Work Order ID 136409

DART AEROSPACE LTD		Work Order:	136409
Description: Bar		Part Number:	D3196-4
Inspection Dwg: D3196 Rev: C		Page 1 of 1

DRAWING NO. D3196	TITLE BAR	REV. C	DART AEROSPACE LTD ENGINEERING ORDER	D.E.O. NO. D3196-C-1	SHEET NO. SHEET 1 OF 2	SCALE NTS
DRAWN ASS	CHECKED A	MFG. APPR. H	APPROVED H	DE APPR. H	DATE 08.08.27	DATE 08.08.28
DATE 08.08.27	DATE 08.08.28	DATE 08.08.29	DATE 08.08.29	DATE 08.09.04

D3196-1 BAR

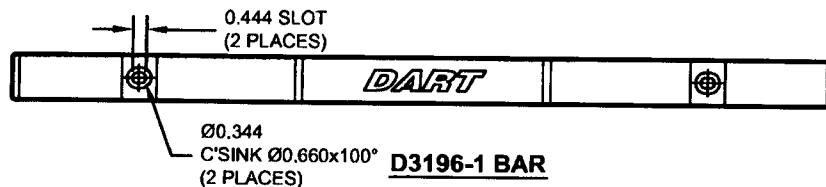
SHEET 1 MODIFY SLOT DIMENSIONING ON D3196-1 AS SHOWN:

D3196-3 BAR

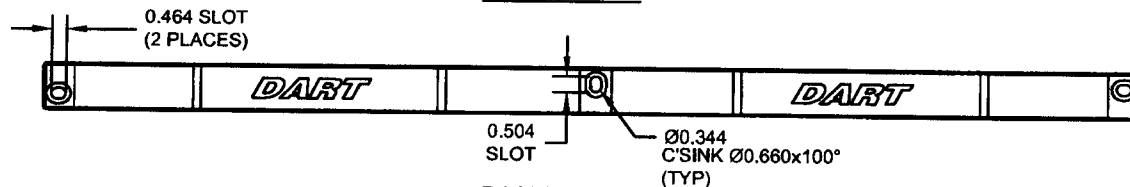
SHEET 2 MODIFY SLOT DIMENSIONING ON D3196-3 AS SHOWN:

D3196-4 BAR

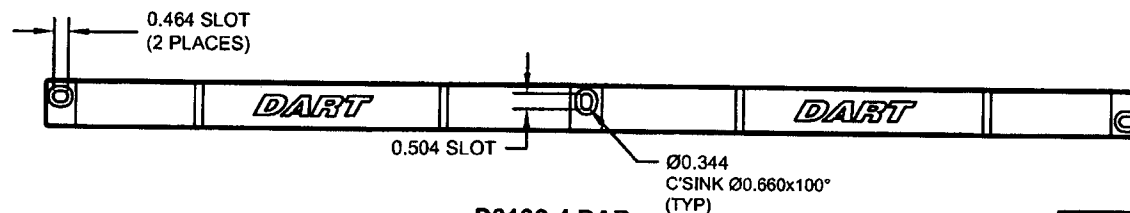
SHEET 3 MODIFY SLOT DIMENSIONING ON D3196-4 AS SHOWN:

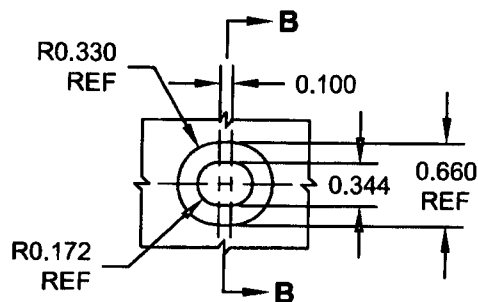
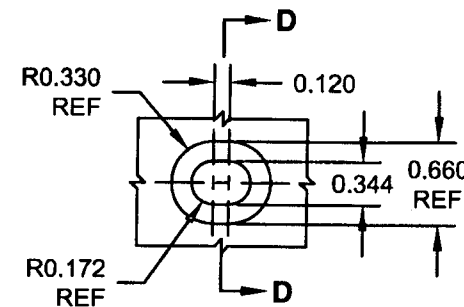
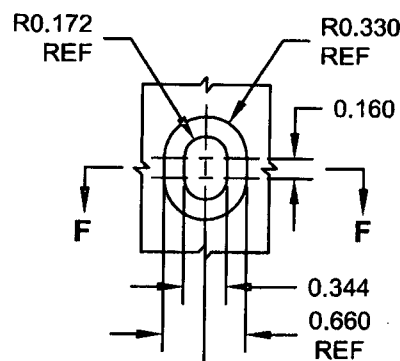
NOTE: THIS CHANGE HAS BEEN DONE TO CLARIFY SLOT DIMENSIONS ONLY. NO CHANGES HAVE BEEN MADE TO THE PARTS
SEE NCR 08-051 FOR FURTHER INFORMATION
ALL OTHER INFORMATION REMAINS UNCHANGED
